ADDENDUM NO. TWO

PROJECT: Proposition 39 Furnace Replacement
Administration Building

OWNER: Humboldt County Office of Education
901 Myrtle Avenue
Eureka, CA 95501

DATE: **October 17, 2017**

1 OVERALL PLAN
1/16"=1'-0"

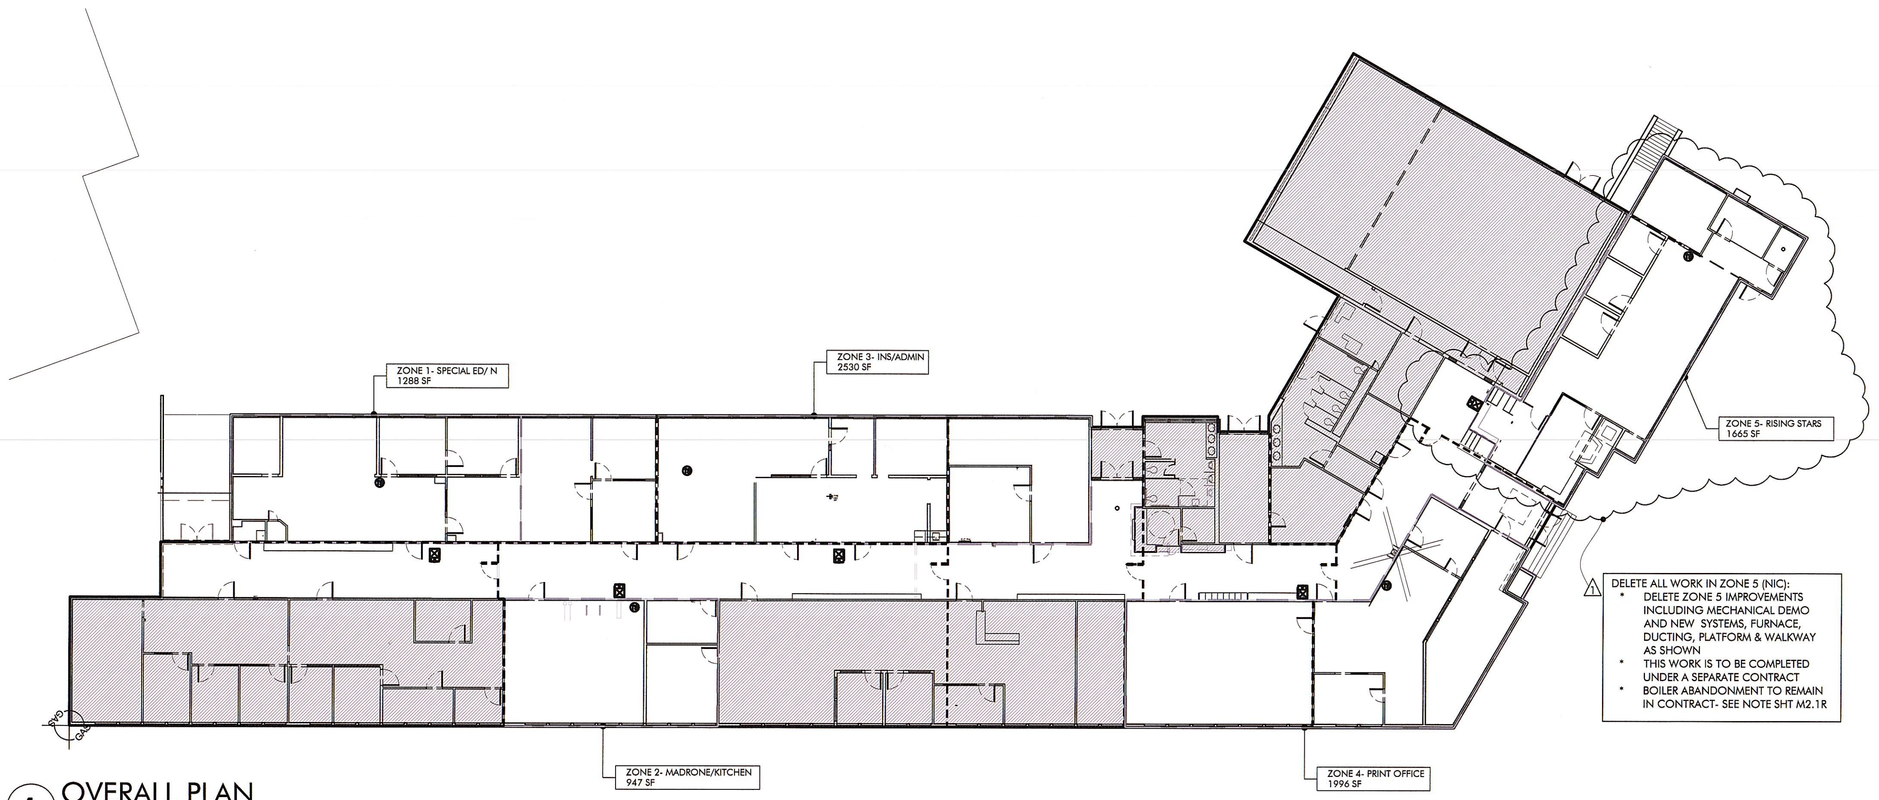
1. CLARIFICATION: DRAFT STOP REPAIR/ RECONSTRUCTION
   A. Repair or Replace (E) draft stops per 3/A3.01. Reconstruct (E) or provide (N) draft stops per 3/A3.01. (7) draft stop areas are shown on REVISED Sheet A2.01R, attached. The location of draft stops may be adjusted such that the maximum area is 3000 SF. (Reference CBC 718.4.3).
   B. Draft stop material may be of ½" GWB, 3/8" plywood, 1" nominal lumber, cement fiberboard, or mineral or fiberglass blankets. At corridor wall conditions (walls perpendicular to the roof framing), install mineral wool or fiberglass batts in the voids at the roof level or wherever otherwise occurring. (Reference CBC 718.3.1).
   C. At locations where draft stops extend to the exterior wall, provide minimum 2x4 framing @ 2'-0" O.C. with one of the covering materials listed above.

2 MEZZANINE & CEILING PLAN
1/8"=1'-0"

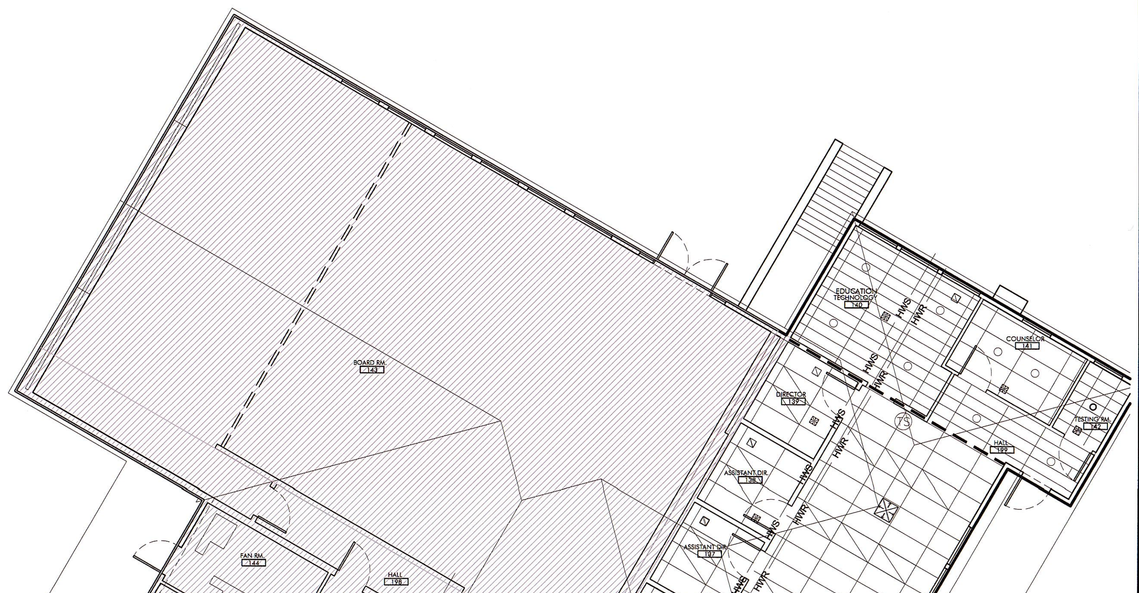
A. A number of the (E) 2x4's at 4' O.C. as called out at 2/A3.01 are not continuous across the corridor mezzanine. They are spliced with nailed overlap pieces. At these locations replace with continuous member or sister new member to side with (2) 16d @ 16" OC.
